Comparison between Channel P2PRUNB specification options

Addressing Opinions/Questions/Inputs from Meeting #11

Contribution for 802.3bt End to End Channel Pair to Pair Resistance Unbalance Adhoc.

Rev 002

Figure 1: End to End Channel P2PRUNB vs Chanel P2PRUNB

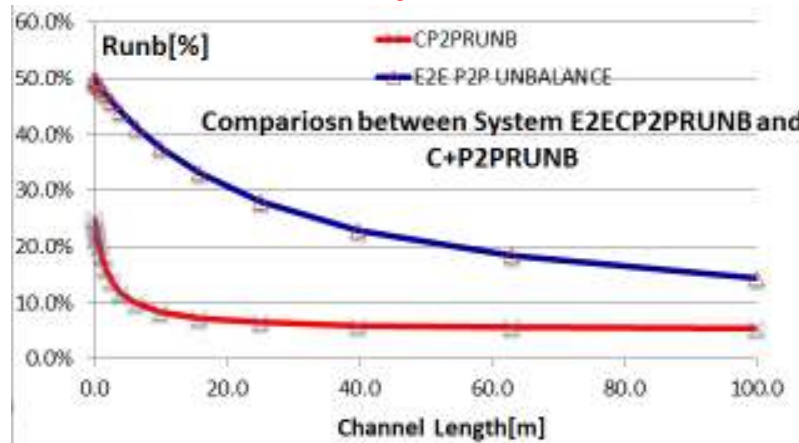
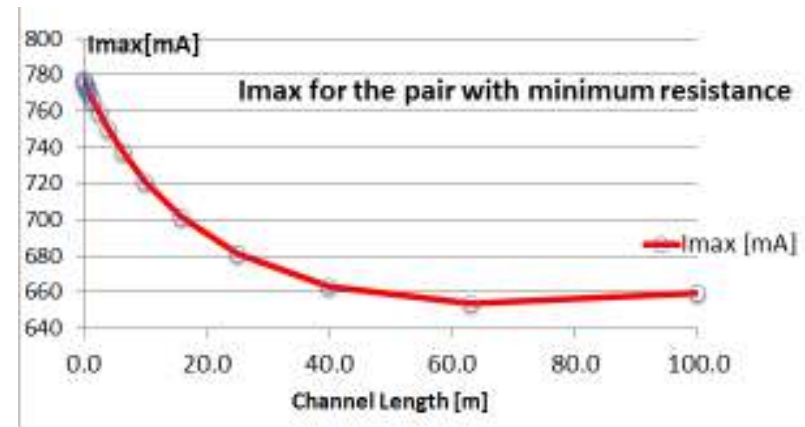
- Using adhoc database values for components. Annex G1.
- The high C_P2PRUNB at short cable is dominating by PSE PI and PD PI components.
- PSE and PD PI affect also the system unbalance at 100m.
- We can see that while channel at 100m is only 5.5%, the end to end P2PRUNB (system) is 15%.
- The End to End Channel P2PRUNB was simulated at 51W load. Confirmed with MATLAB and Excel tools.
- If mistakenly someone runs system simulations with only the channel, the current over the pair with the lower resistance will be more sensitive to channel margins at 100m and will be resulted with wrong conclusions.

- Figure 1 and 2 based on the following system data taken from Annex G1 at the adhoc database material. PSE PI Rmax=0.4405Ω, PSE PI Rmin=0.09Ω, PD PI Rmax=1.061Ω, Pd PI Rmin=0.385. **This values are for pair i.e. the common mode resistance.**
 - This is an example of a system with high PSE and PD unbalance. The 1.061 Ω represents the equivalent PD PI Rmax including the diodes Vdiff and Rdiff unbalance.
- See Figures 3 and 4 for a PSE and PD with lower unbalance parameters.

Figure 3: End to End Channel P2PRUNB vs Chanel P2PRUNB

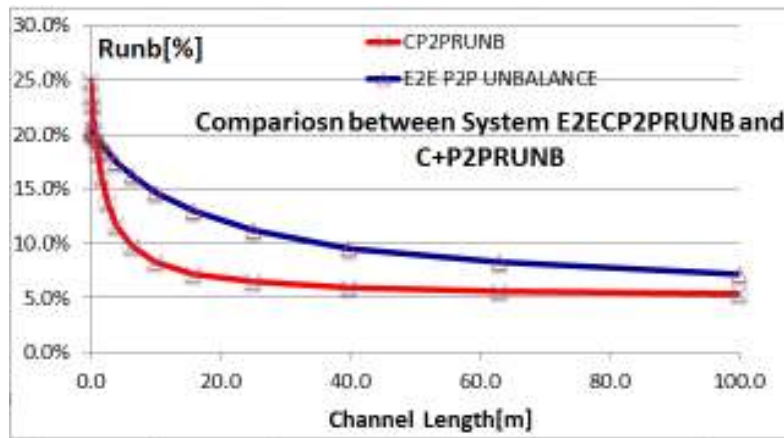
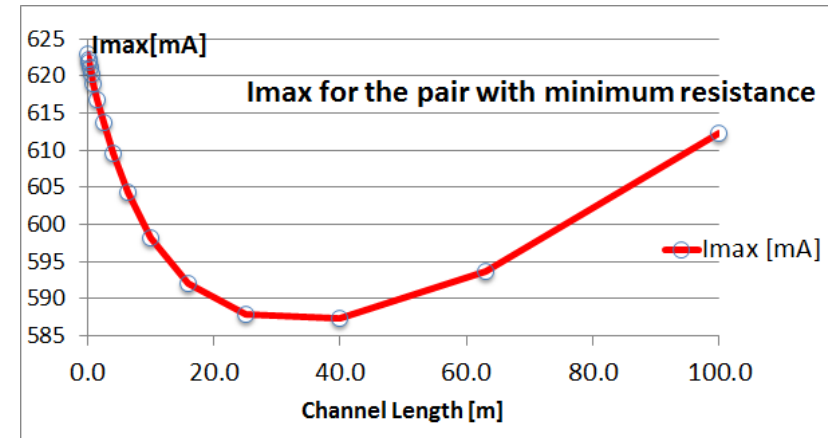
Figure 3 and 4 based on the following system data taken from Annex G1 at the adhoc database material some of the components with better unbalance parameters. PSE PI Rmax=0.2Ω, PSE PI Rmin=0.09Ω, PD PI Rmax=0.511Ω, Pd PI Rmin=0.385.

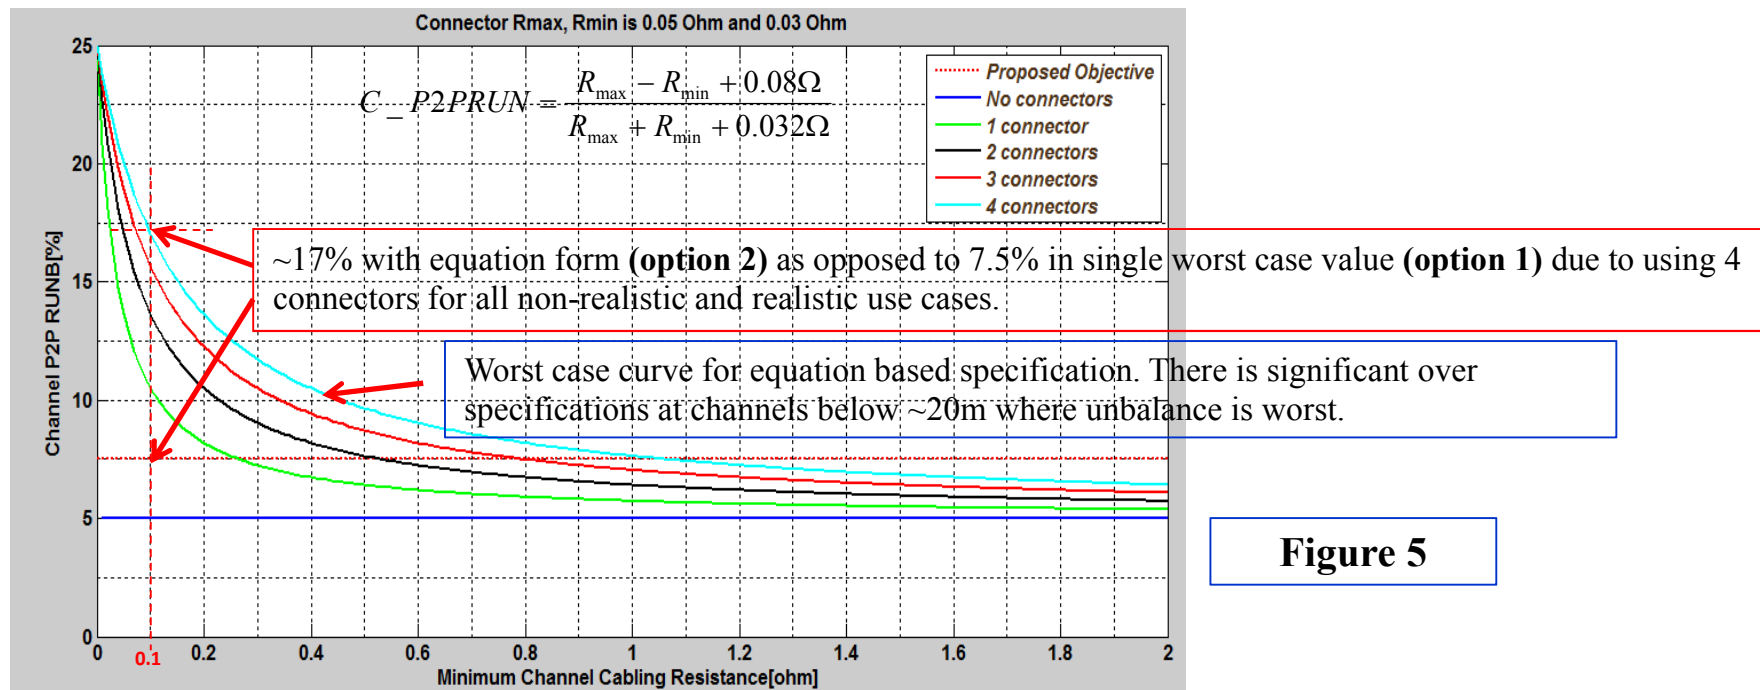
What if the 7.5% will be used in the system equation (EQ-2) instead of channel equation (EQ-1)?

- AT 100m, The 2% margin will be overtaken by the PSE PI and PD PI which are $\gg 5.5\%$ (10-20% at system level pending PSE/PD PI components).
- It is easy to quick calculate it:

- The system has 15% unbalance at 100m. The current is per simulation 659mA.
- The Channel unbalance at 100m increases from 5.5% to 7.5%=2%.
- The current in system level was increased to just 668mA. **This is only 9mA at 51W.**

- 14mA at 80W.
- Only 1.4% increase in pair current due to 2% margin in the channel level.
(Higher effects as claimed at adhoc meeting #11 was due to error in the commenter’s model and calculations as expected. The source of the error is that the commenter use only channel in the system level for calculating the pair current without accounting for PSE and PD PI. It will be also incorrect if it will be argued in the future that there is a PSE or PD that has unbalance qualities similar to the channel i.e. 5.5%. This is not practical. PSE PIs and PD PIs have connector and transformers and other components that has $\gg 5\%$ unbalance. See adhoc database for details.

In this case the effect will be not significant as well.

Figure 6: Option 1 specification derivation based on the general case of channel equation (EQ-0) AND use case analysis

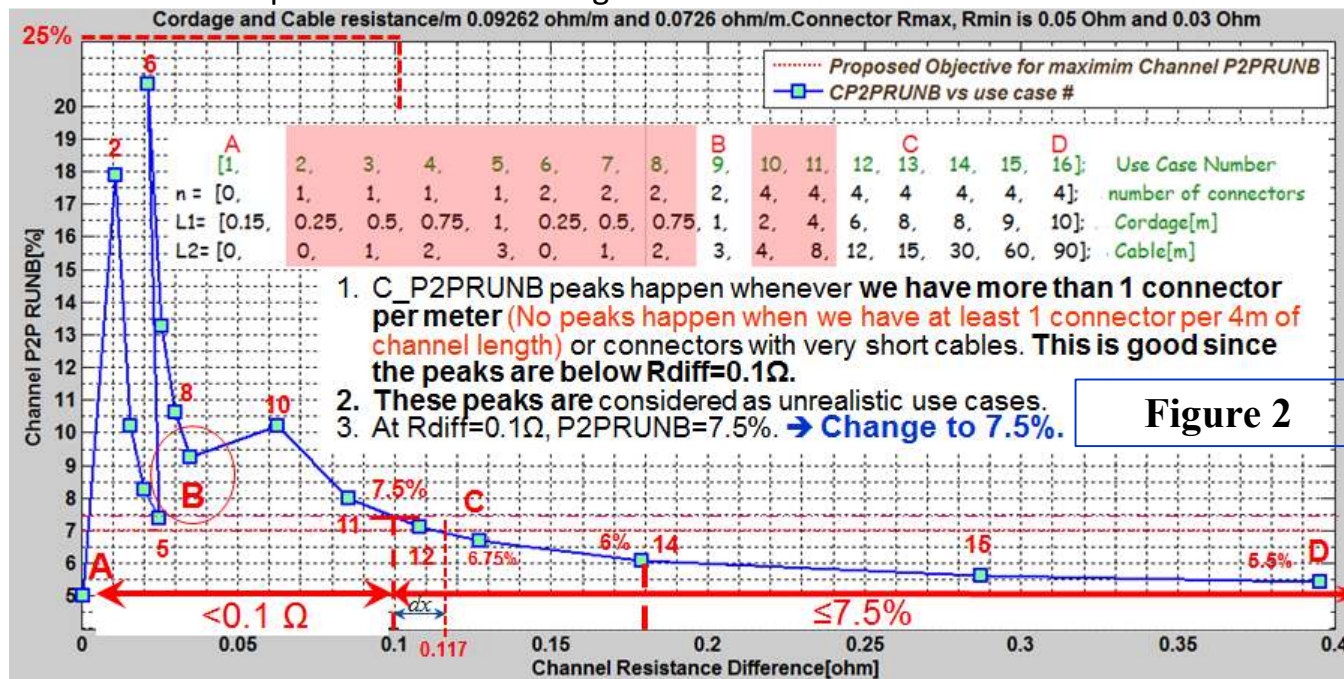
- The base line proposal main part: “100 milliohms or 7.5% whichever is greater
- Use Case optimized and yet based on Channel Equation!
- No wasted margins. This is only Channel spec. System specification is not affected with any way we go.
- Optimized margins at short and long channels
- Simple specification.
- Single worst case value.
- Below 100 milliohms, C_P2PRUNB is limited by 25% (worst case connector data). (Slide 22 in the link below)
 - It can be part of the normative text or as a note.
 - Group to discuss at meeting #12.

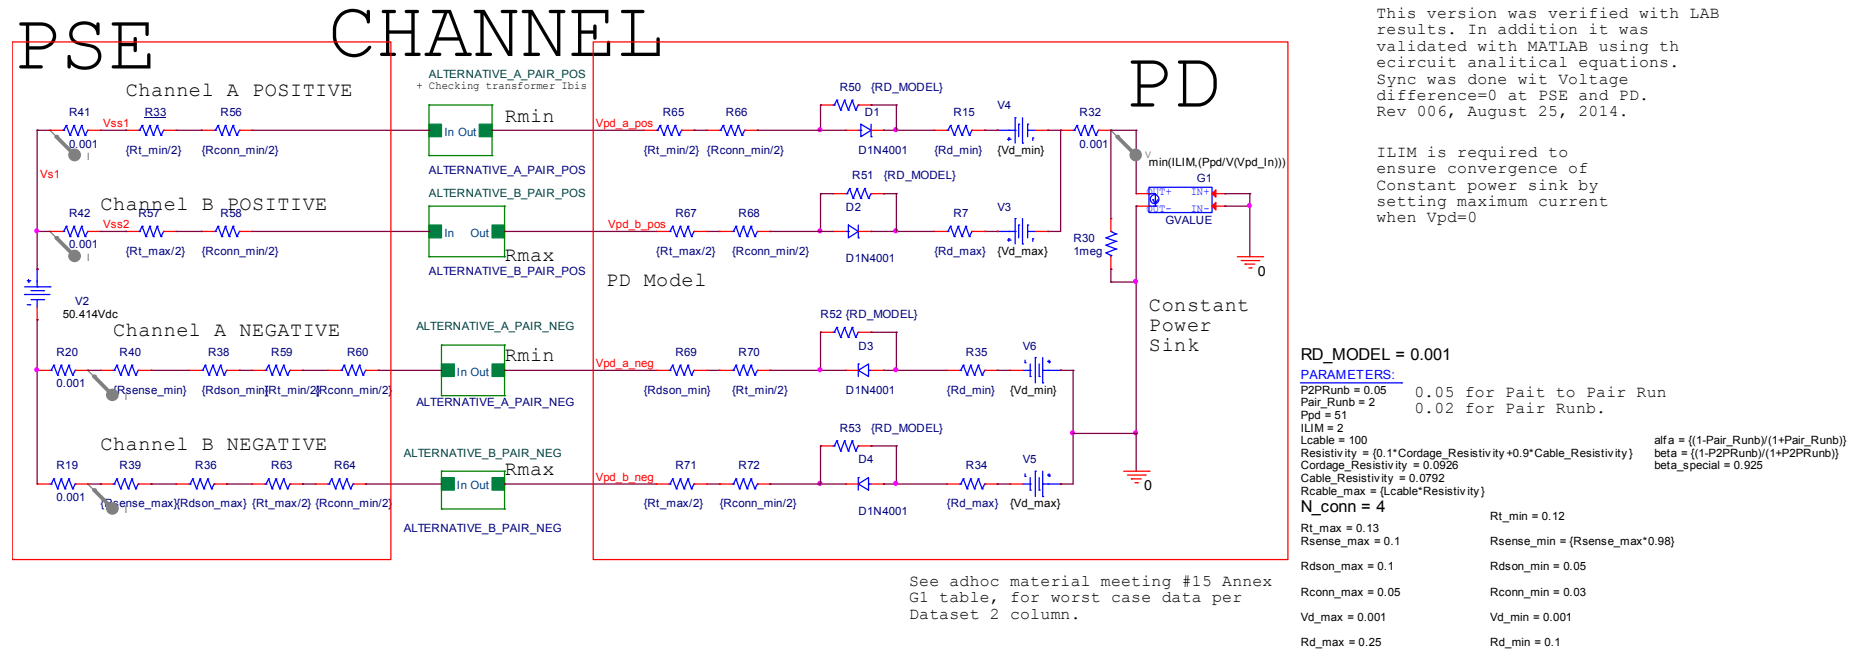
- 11.1 It may be interpreted as allowing cabling (not including connectors) P2P resistance unbalance of 7.5%, and the cable manufacturers may loosen their specs accordingly.

- 11.2 It can also be interpreted as allowing nearly infinite mismatch for a short channel since we don't define (in section 33.1.4.3) what the minimum connector resistance is. Because of the complex relationship between % mismatch and cable length, it's very easy to misinterpret this seemingly simple spec!

My proposal: We remove this worry by adding the following notes.

- d) The above requirements are based on cable with pair to pair resistance unbalance of 5% maximum.

- Infinite mismatch is impossible. The maximum possible unbalance is 100%.
- So if you meant 100% maximum, I agree and I have addressed it in my work see: http://www.ieee802.org/3/bt/public/jul14/darshan_01_0714.pdf slide 22 that address it and suggest that it will be a subject for later work based on the analysis we already done and we have all the information in this link were we see red dashed border limits at 25%.
